ADDENDUM NO. 1
TO THE
DRAWINGS AND SPECIFICATIONS
FOR THE
Moores Pike (College Mall to Woodruff) Sidewalk

Issue Date: July 23, 2019

Item No. 1: A revised "Moores Pike Sidewalk Project Index and General Notes" Sheet 2 of 32, has been issued and is attached to the addendum. The project shall be built as shown on the revised sheet.

INLET RECONSTRUCTION DETAIL

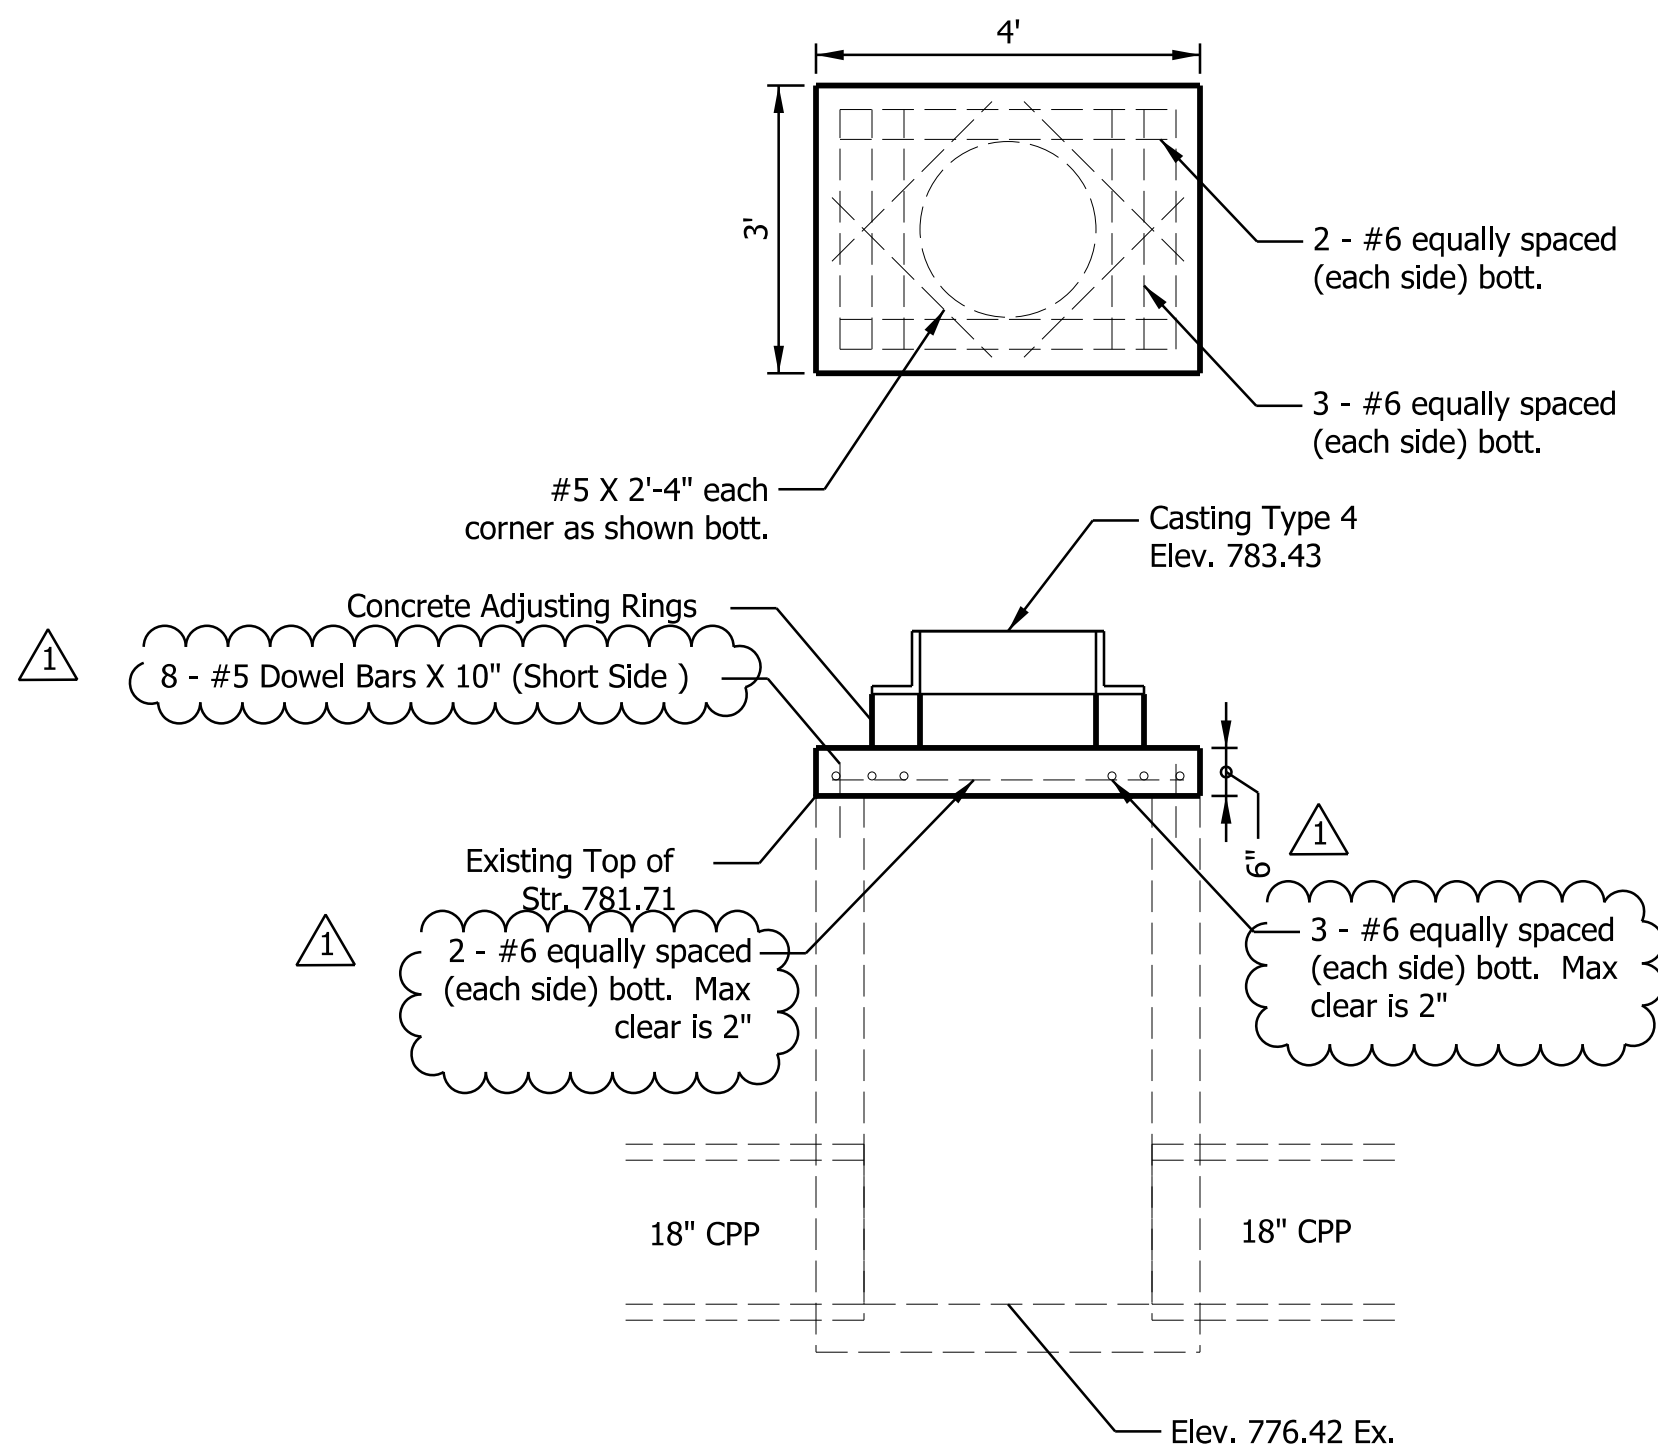
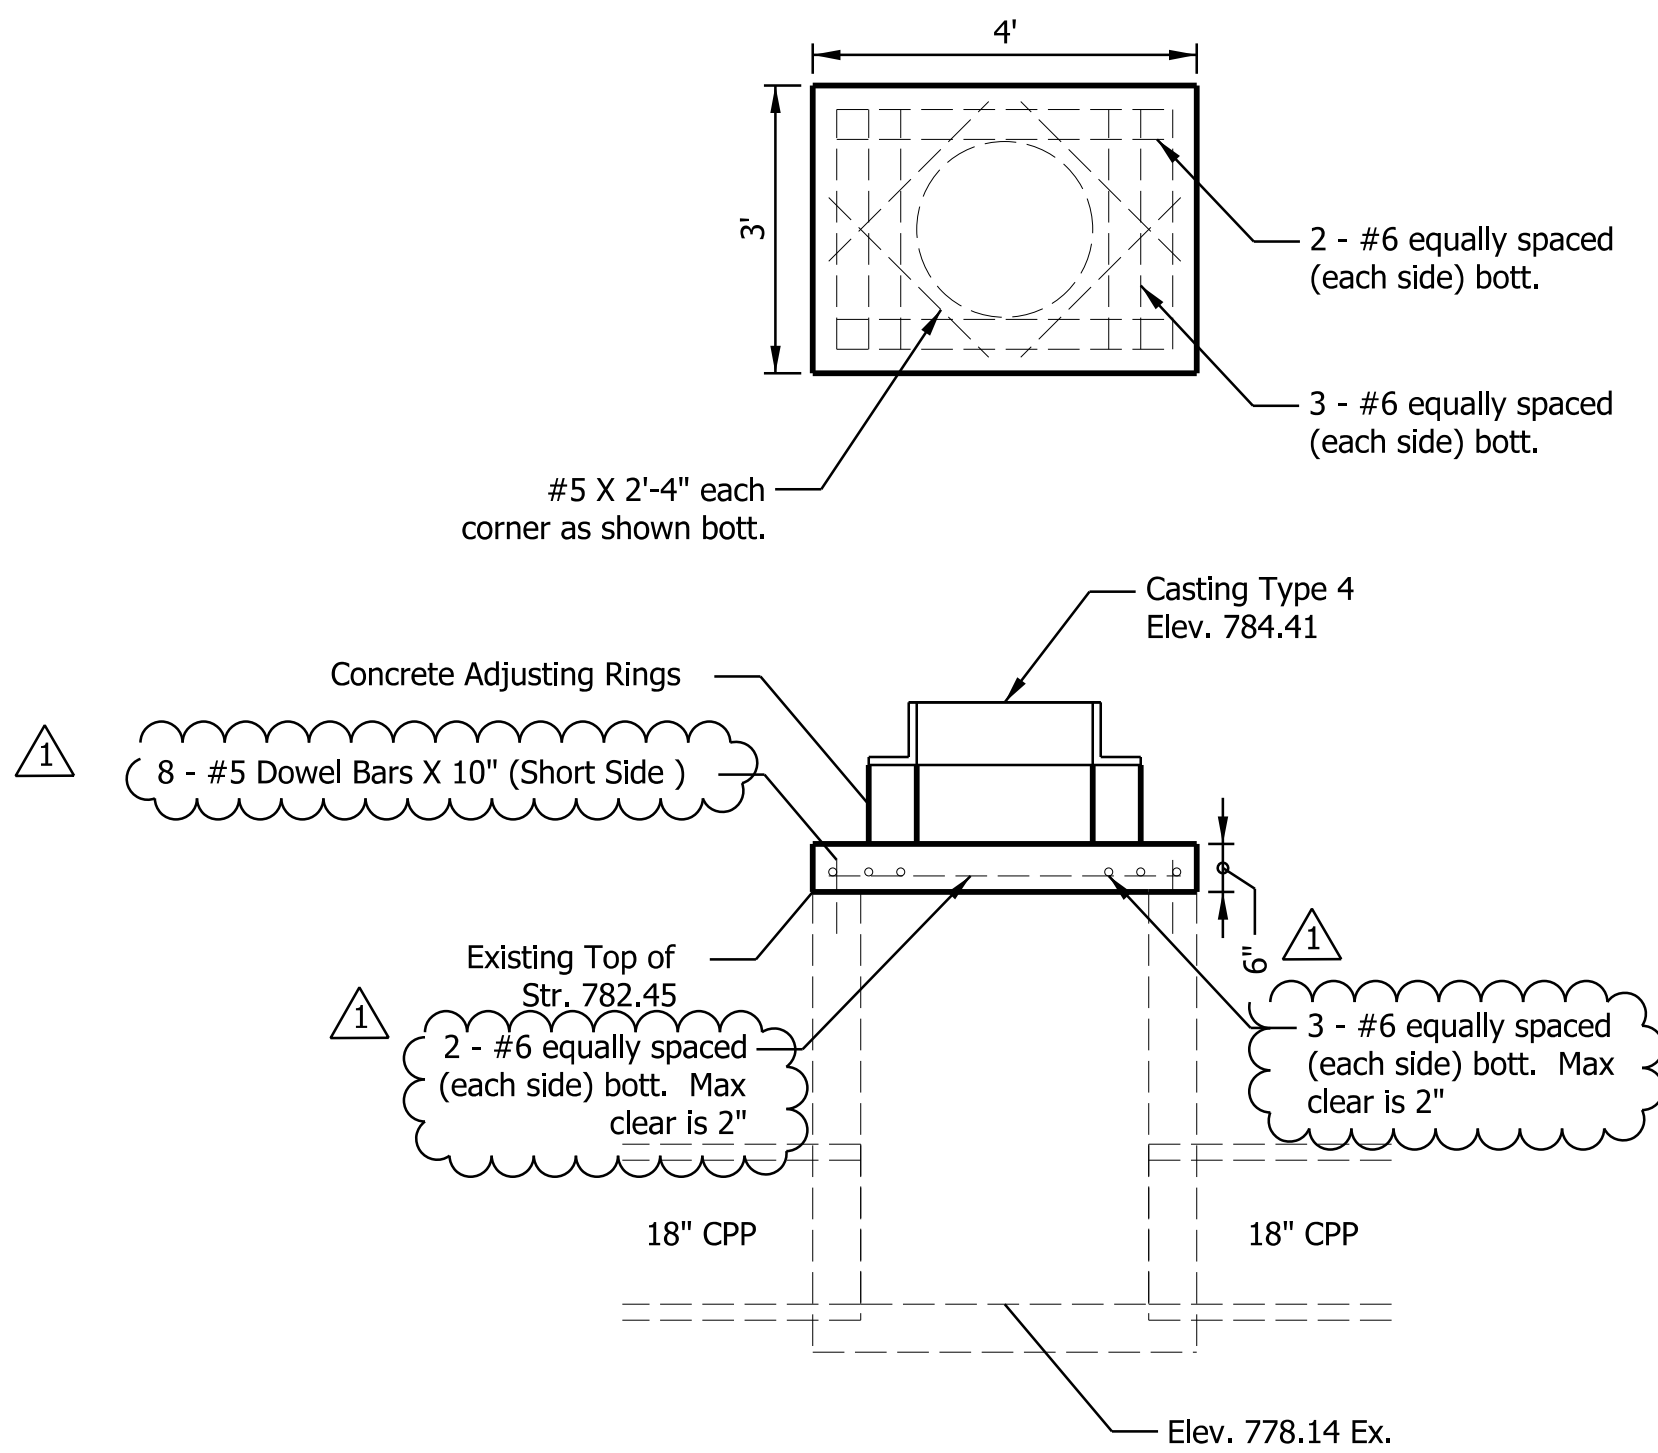
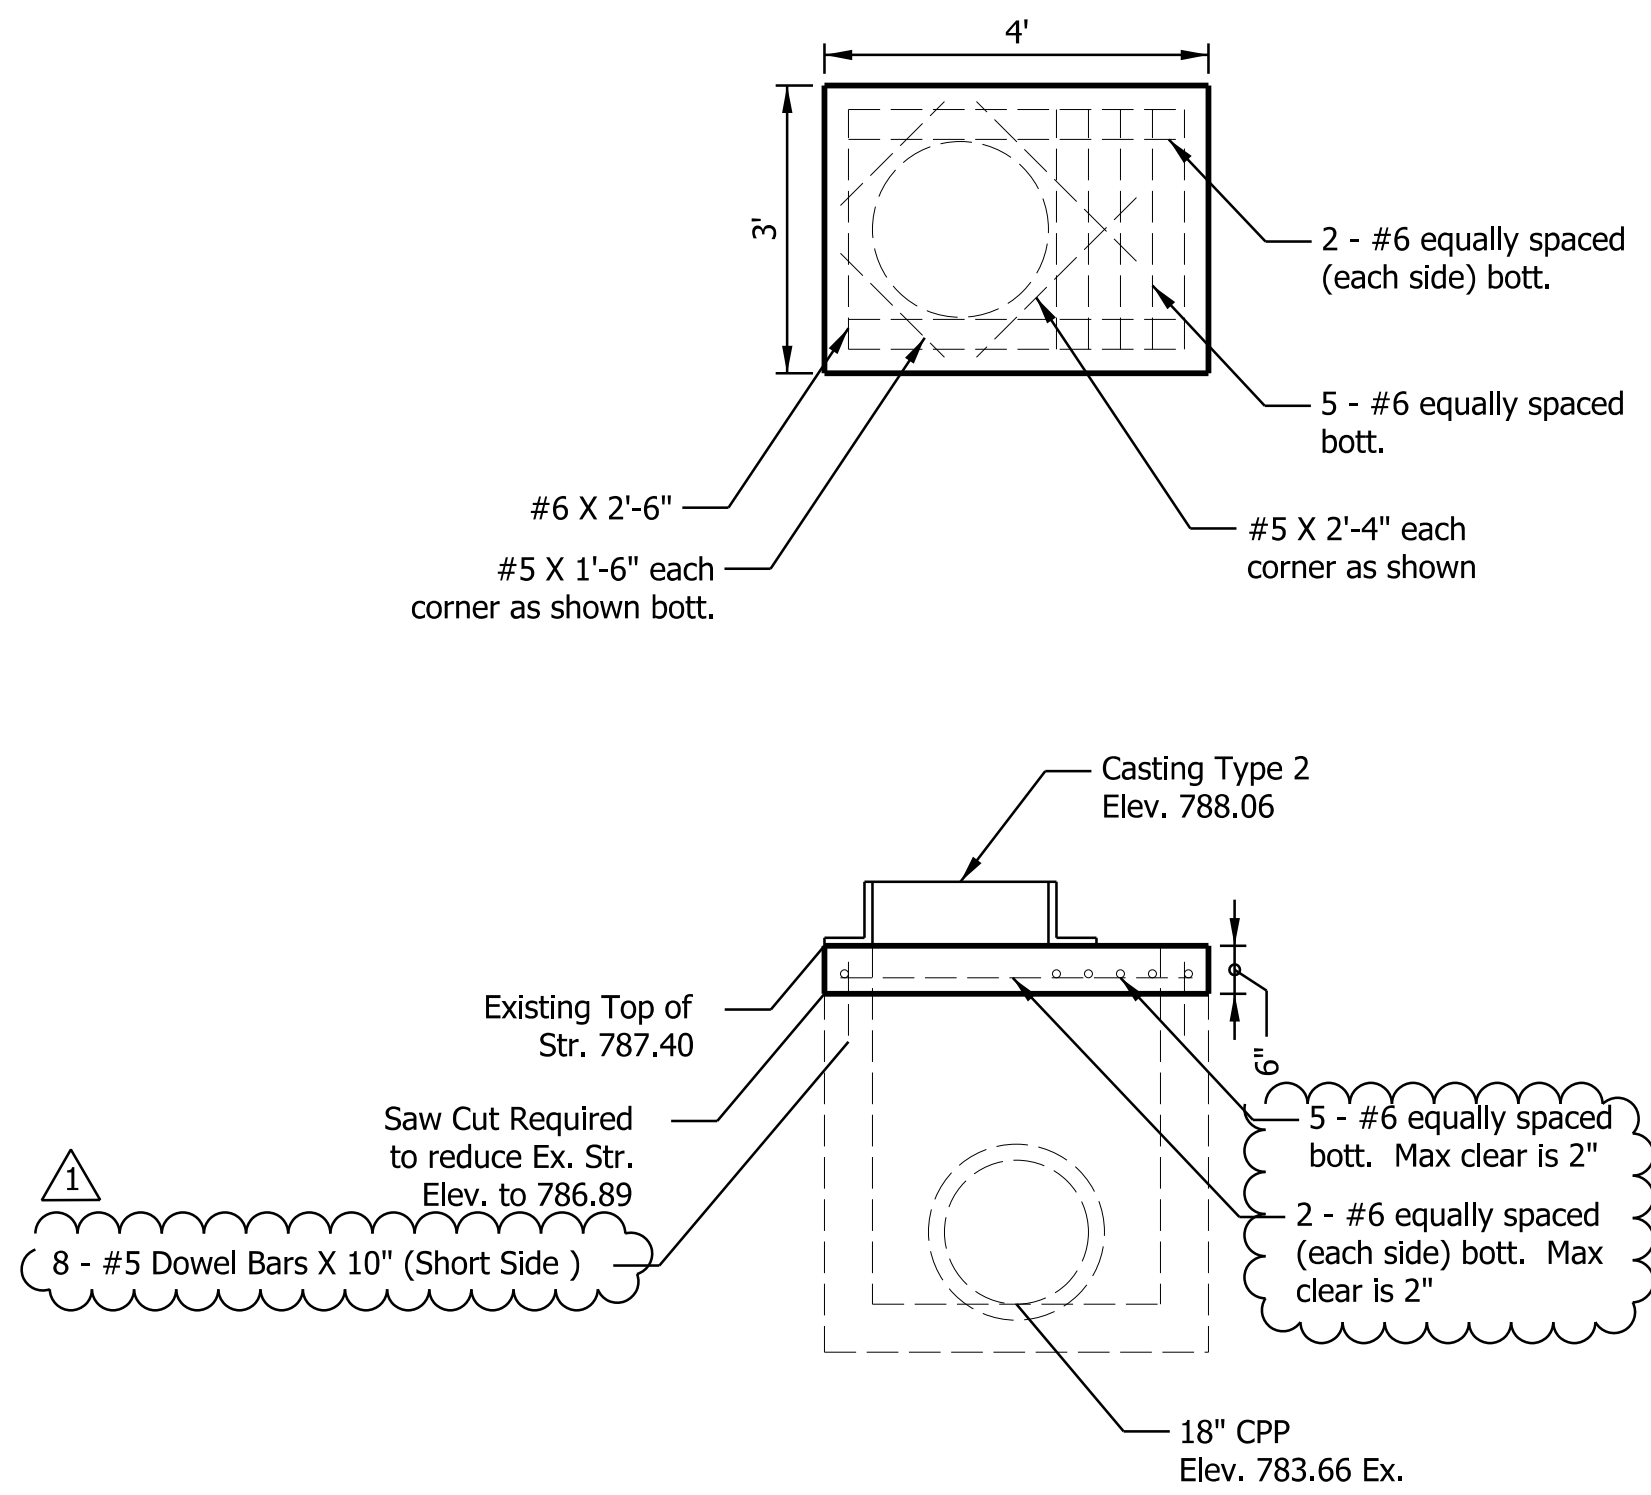
Revisions		
Sheet No.	Date	Revised
18	7/18/2019	Revised notes for reinforcing steel and dowel bars

07/18/2019 - Revised plan notes for reinforcing steel and dowel bars

Note:
1. Reinforced concrete inlet lid to be included in the cost of the Contract Unit Price of "Inlet Reconstruct"
2. Costs for preparation of the existing inlet, drilling and adhesive to install dowels shall be included in the Contract Unit Price of "Inlet Reconstruct"
